24' X 36' RELOCATABLE CLASSROOM

Re: CRA Project #05049.11

RE: CRA Project #05049.11

Re: Design Space - 24' x 36'
CRA # 05049.11

HVAC UNIT FASTENING

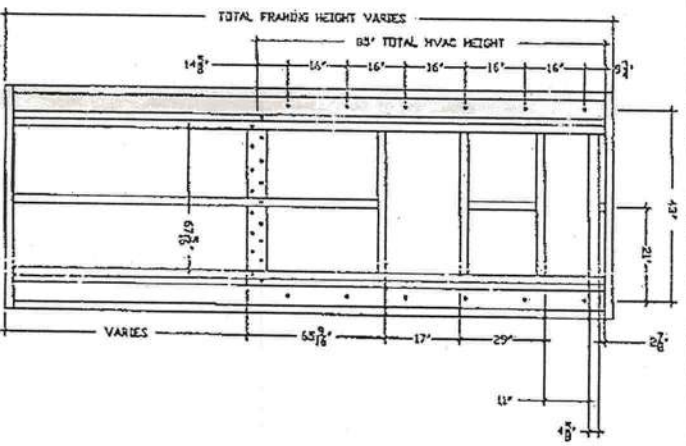
3. **Location:** Sheet 5
Deficiency: Mechanical equipment, appliances and supports that are exposed to wind shall be designed and installed to resist the wind pressures determined in accordance with the Florida Building Code, Building.
Provide sufficient design detail of supports and anchoring to verify the AC unit is properly secured.
Reference: Florida Building Code, Mechanical 301.13.

FASTENERS FOR HVAC SUPPORT ARE BUILDEX 1/4" HHW #3 POINT TRAXX SCREWS OR EQUAL FASTENED INTO 3625162-43 STEEL STUDS OR BETTER. INSTALL 6 FASTENERS INTO EACH SIDE BRACKET AND 17 FASTENERS INTO BOTTOM BRACKET. STUDS SHALL BE FASTENED TO ADJACENT STUDS WITH EQUIVALENT FASTENERS AT 12" o.c.

1. Mechanical equipment schedule has been added to sheet 2.
2. Plumbing equipment schedule has been added to sheet 2.
3. For anchorage of AC unit see "HVAC unit fastening" on sheet 2.
4. Lower left corner of sheet 4 specifies design water pressure. 60 psi is the maximum allowed pressure for this building.
5. See plumbing note 8 on sheet 2 for shutoff valve specification.
6. See HVAC note 7 on sheet 2 for outside air intake specification.

WALL HEADERS

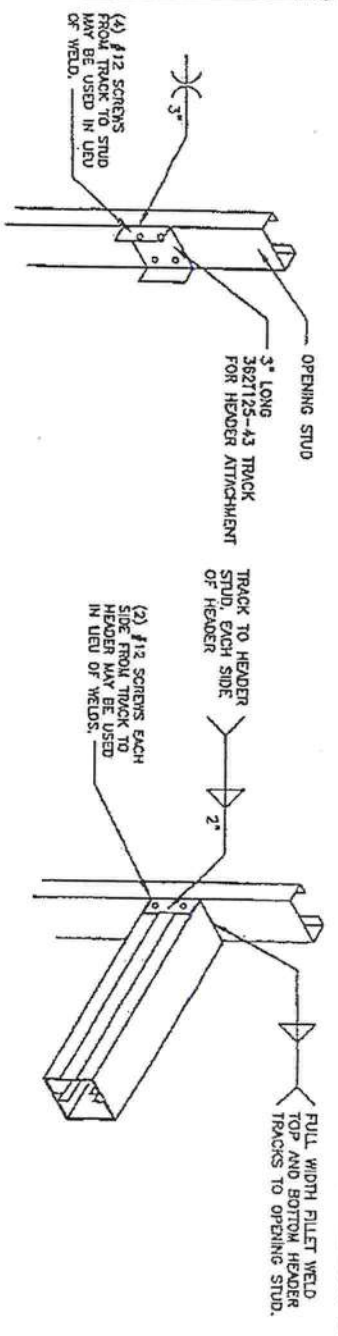
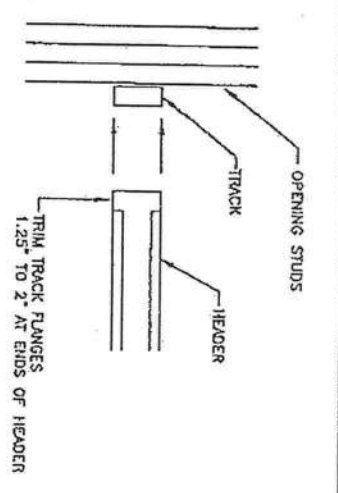
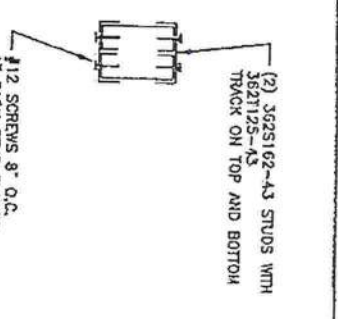
1. **Location:** Calculations and Drawings
 Deficiency: Floor decking material shown as 3/4" Viroc. Load-Span tables
 from manufacturer should be included in submittal. Also the
 Florida Product Approval number should be submitted for this
 product.
2. **Location:** Drawing Sheet 10
 Deficiency: Detail of exterior wall openings do not indicate the number of
 required full height studs each side of the opening. Calculations
 include tables indicating the maximum opening width allowed
 based on the number of full height studs each side. Revise
 drawing to indicate this information.

1. Span tables for Viroc have been added to calculations. Viroc will not be used to resist wind loads so Florida Product Approval number should not required. A calculation has been added to verify the capacity of the perimeter floor beam to carry wind loads without the use of Viroc.
2. The plans indicate the number of studs required on each side of openings on the left side of the cross section on sheet 8.
